ARMORED MEDICAL RESEARCH LABORATORY

Final Report

PROJECT NO. 41 - PHYSIOLOGICAL AND OPERATIONAL CHARACTERISTICS
OF TANK T25E1.

8 November 1944

FIG. 2
LIMITS OF LEADERS GROUND VISION
T 25 EI TANK

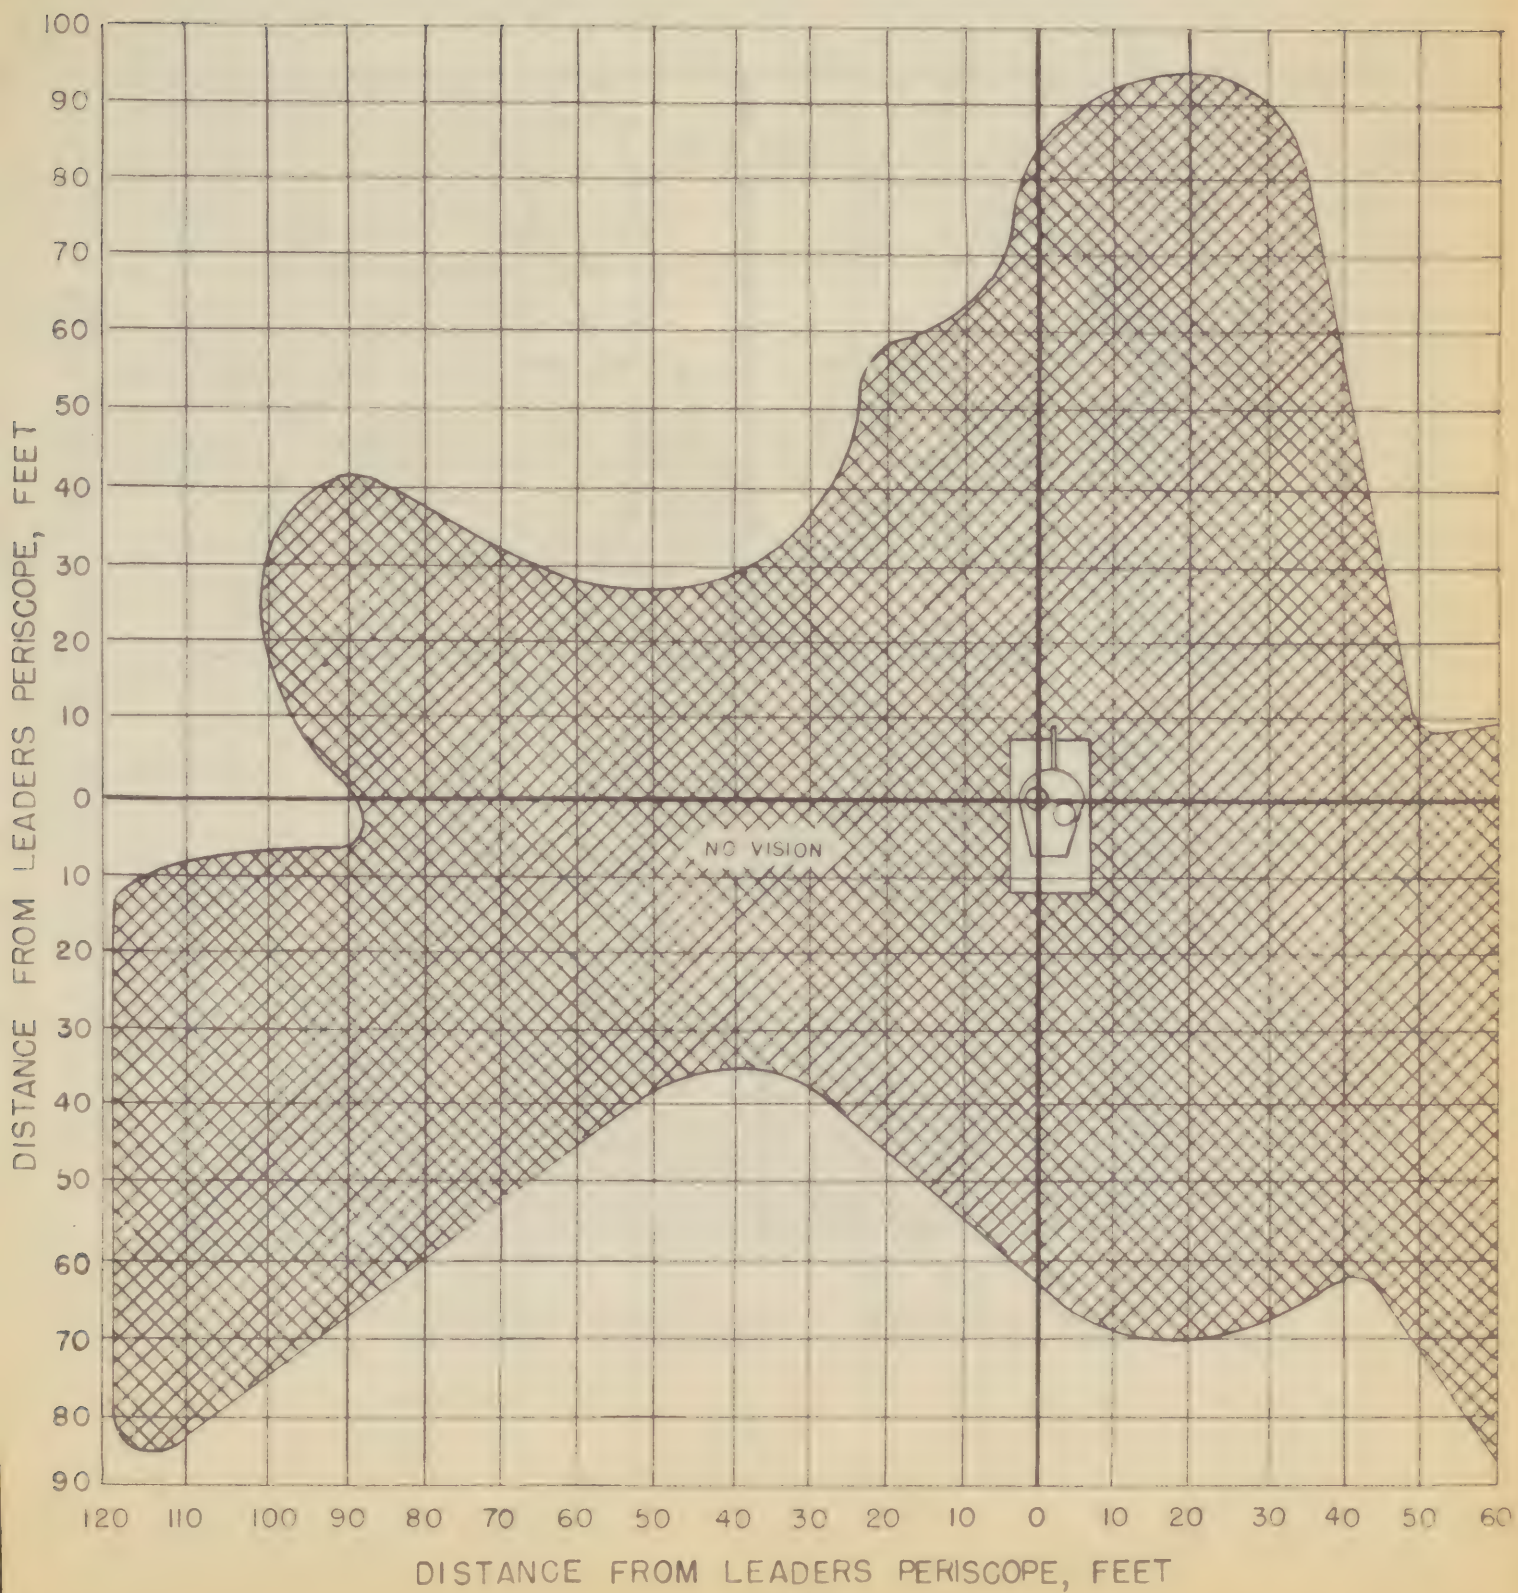
b. Loader: The limits of ground vision provided through the loader's periscope are shown in Fig. 2. The closeness of vision to the tank is not greatly improved over that of the commander. Since the loader is the only crew member who is in a position to obtain close vision on the left, improvement is required. This can be obtained by the installation of rhombic vision units in the side armor.

b. Provide rhombic vision units in turret wall for loader, in order to secure near ground vision.

FIG. 3
LIMITS OF DRIVERS GROUND VISION
T25 EI TANK

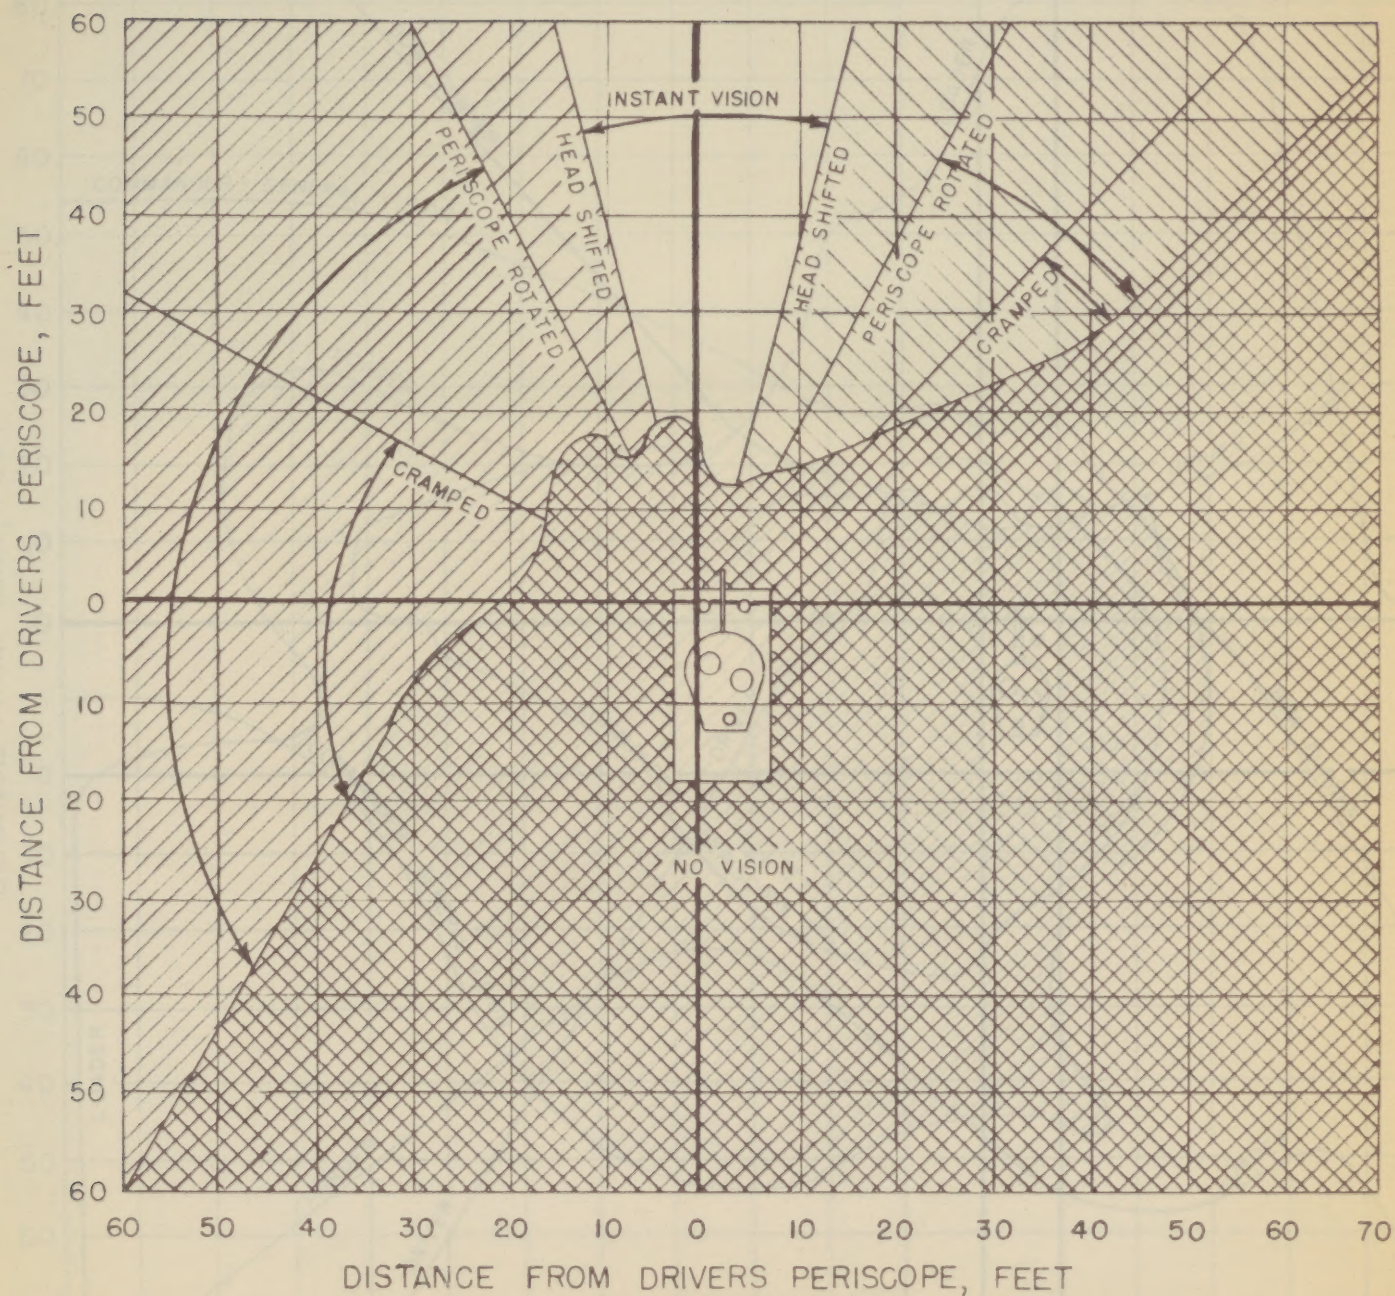
c. Driver: Limits of ground vision are shown in Fig. 3. The M6 periscope is unsuitable for driver vision owing to its restricted field of view. Furthermore, the driver cannot conveniently make the continual re-adjustments necessary to gain even partial knowledge of the ground to be traversed. The secondary periscope is too inaccessible to supplement vision through the main instrument. The rib which projects down around the inside of the hatch and the projection of the turret ring bearing interfere with the driver's head movement and prevents his effective use of the secondary periscope.

c. Provide driver with wide field vision units (blocks or rhombs) possibly supplemented by periscope for cross-tank vision.

FIG 4

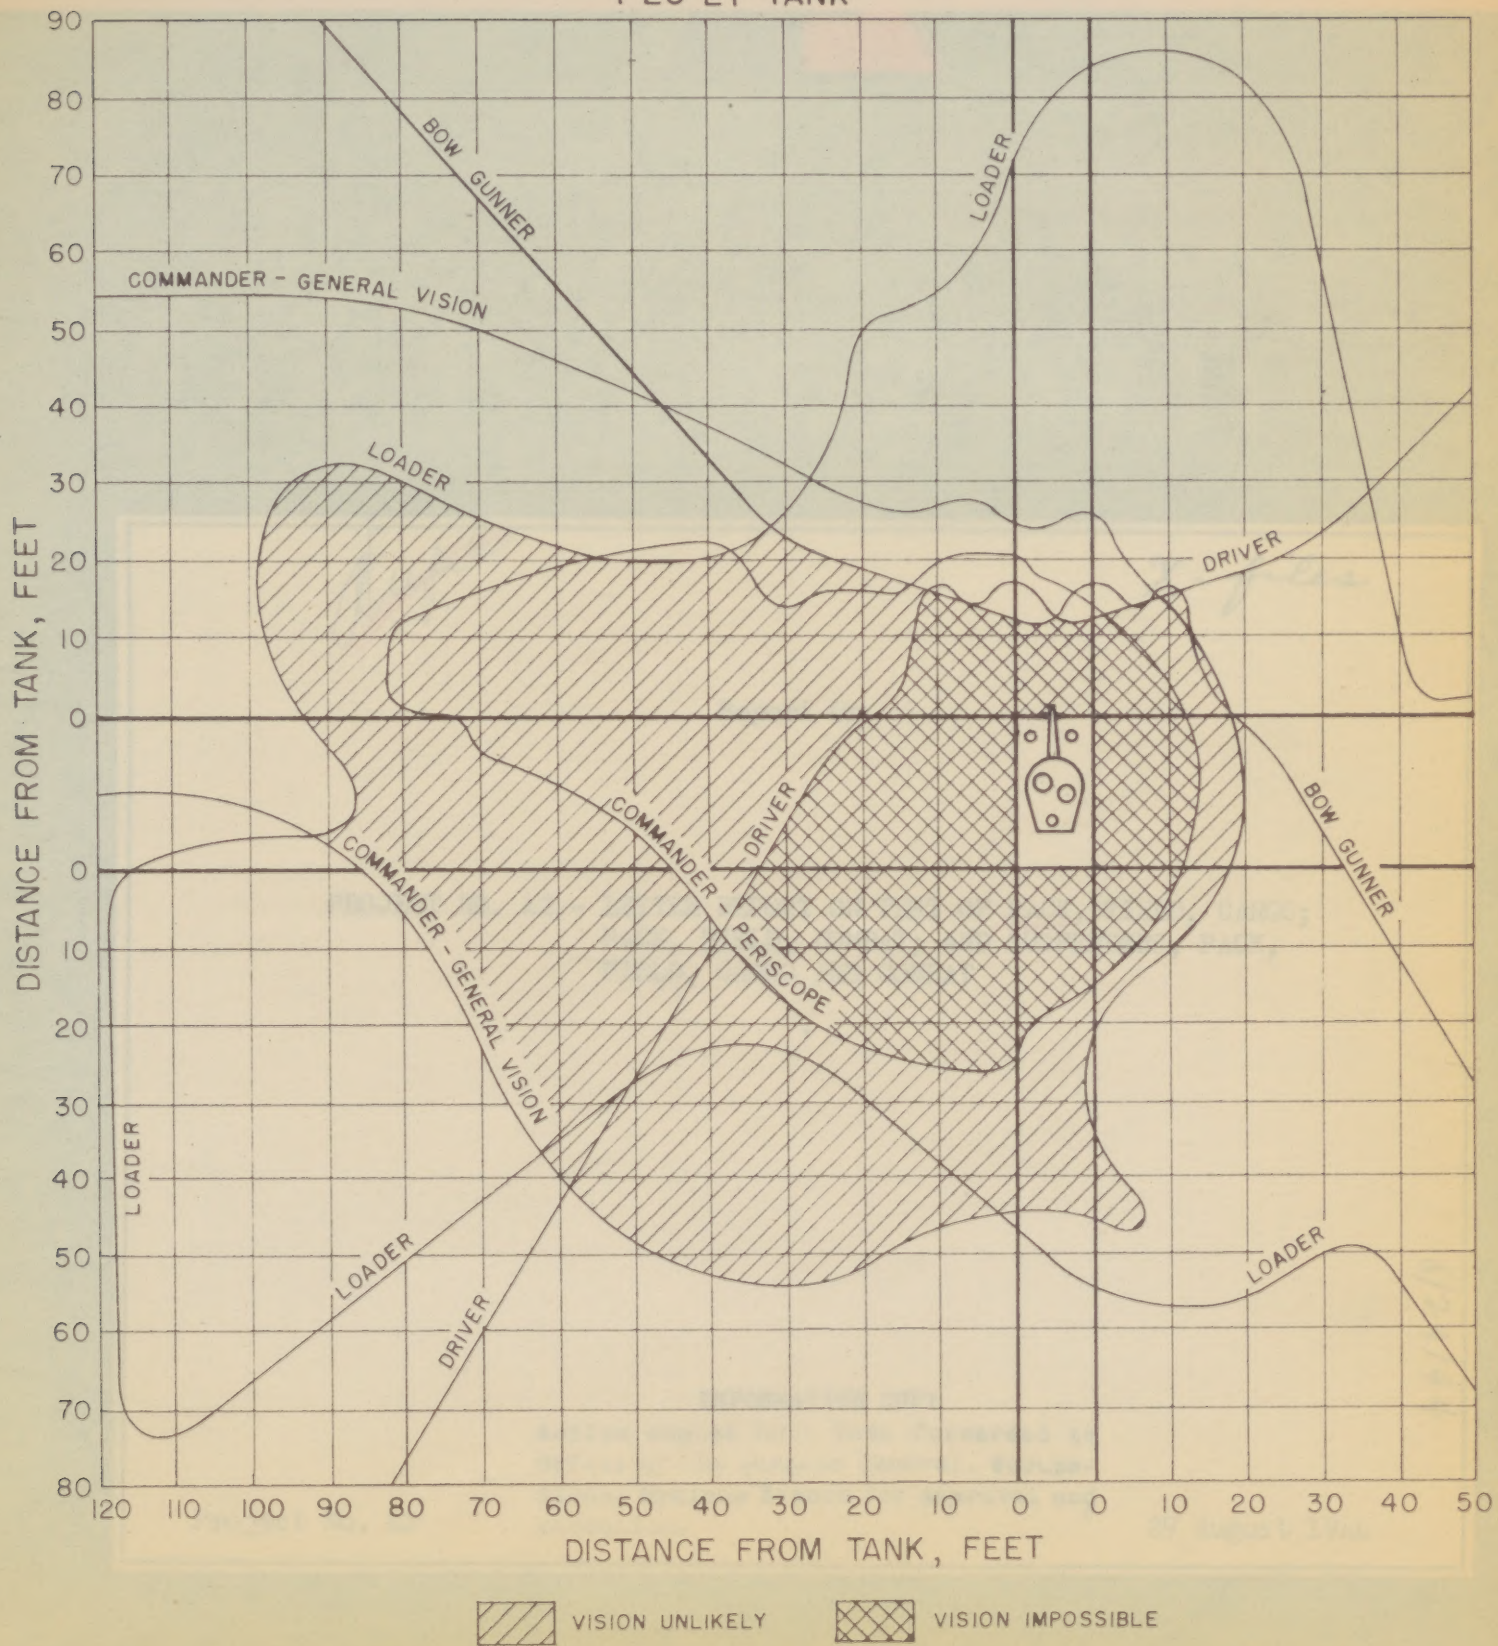
d. Combined Vision: Immediate and close-in ground vision surrounding a tank becomes increasingly important when operating in terrain which provides close infantry cover. The overall limits of ground vision provided in the T34, shown in Fig. 4, fail to provide this necessary close-in vision. The vision cupola is especially lacking in downward vision and the raised ring of the loader's hatch obstructs cross-tank vision from the cupola. The large flat turret top sets a limit to downward vision from any vision device placed low in the rood.

a. Immediate consideration be given to the development of an improved vision cupola with less limited ground vision. In new design provide for hatch inside rotor as previously recommended, rather than with rotor in the hatch.
